**REVIEW OF ALARA PLAN FOR ACTIVITIES
AT THE 105 K-EAST FUEL STORAGE BASIN**

September 1994

Pacific Northwest Laboratory
Richland, Washington 99352

Figure 3.3. Basin Cooling Water System Piping Showing Major Contributors to Personnel Doses in the Technical View Pit Area

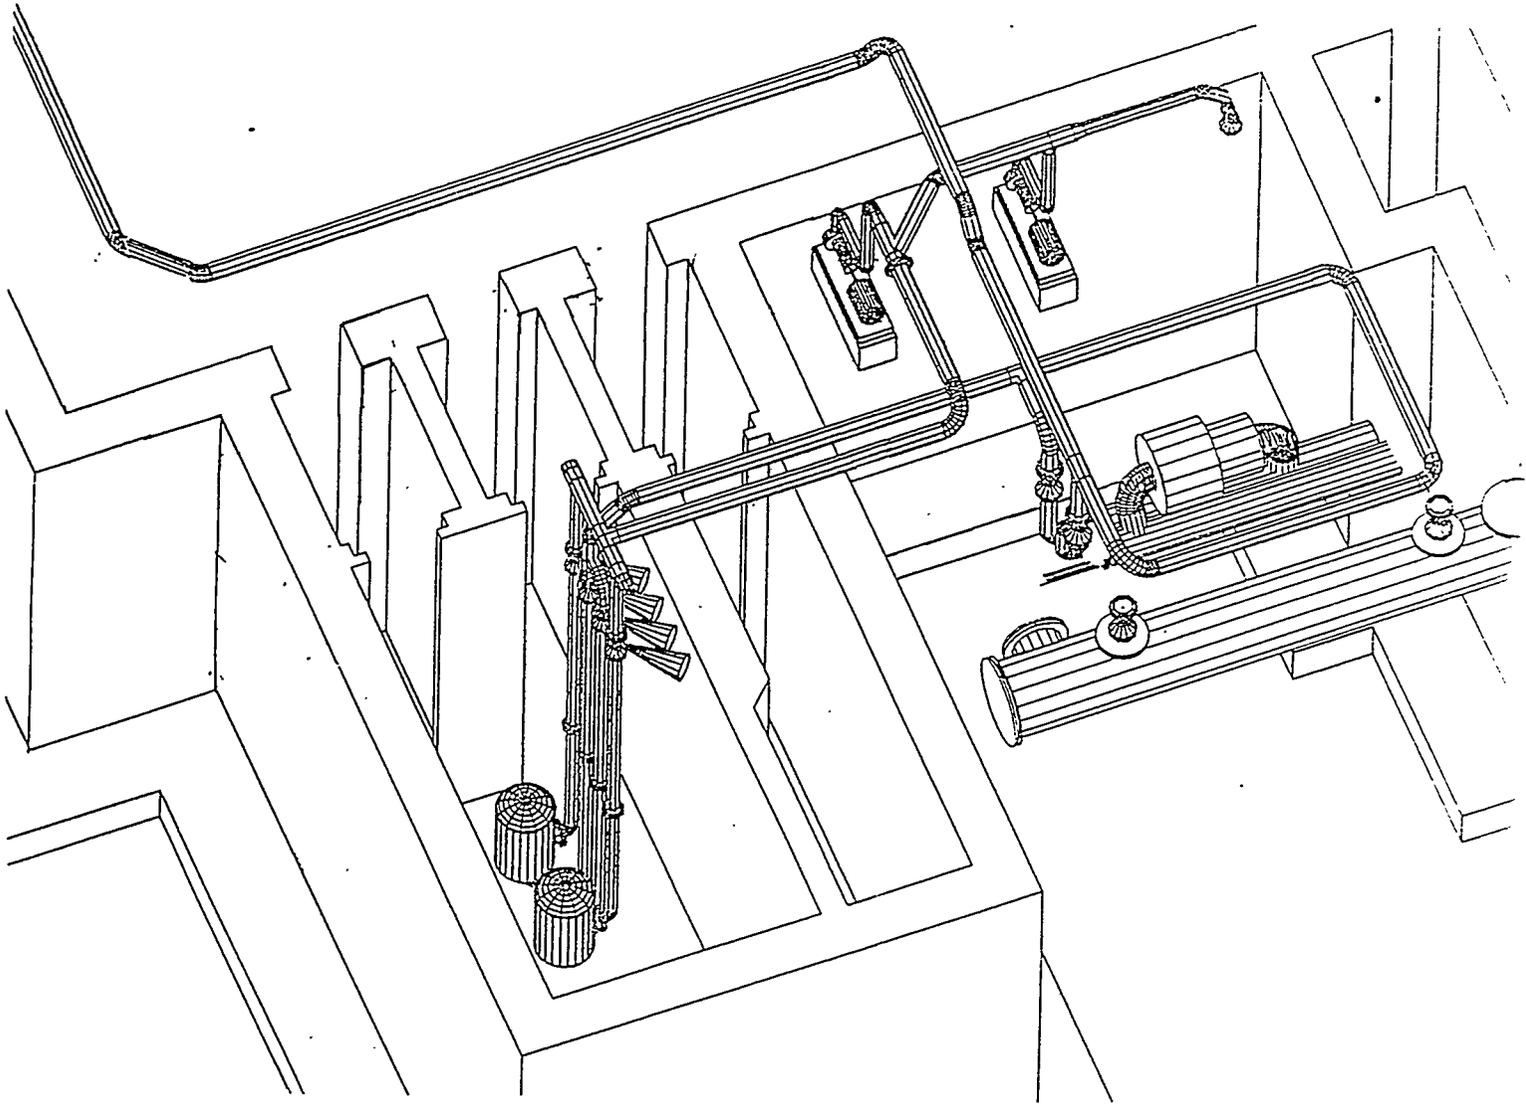
Two separate, but related, systems maintain FSB water quality and remove decay heat. The FSB cooling water system consists of three inlet lines (one drawing from the south end of each FSB bay), a recirculating pump, two 5- μm cartridge filters, a chiller, and a return line to each FSB bay. This system operates at a design flow of 500 gallons per minute (31.5 L/s) and also supplies the IXCs if they are placed in service. The FSB water-cleaning system consists of skimmers, a skimmer pump, a sand filter, and return piping. This system operates at a design flow rate of 400 gallons per minute (25.2 L/s). The skimmer pump supplies the IXMs. The general system configuration is shown in Figure 3.3.
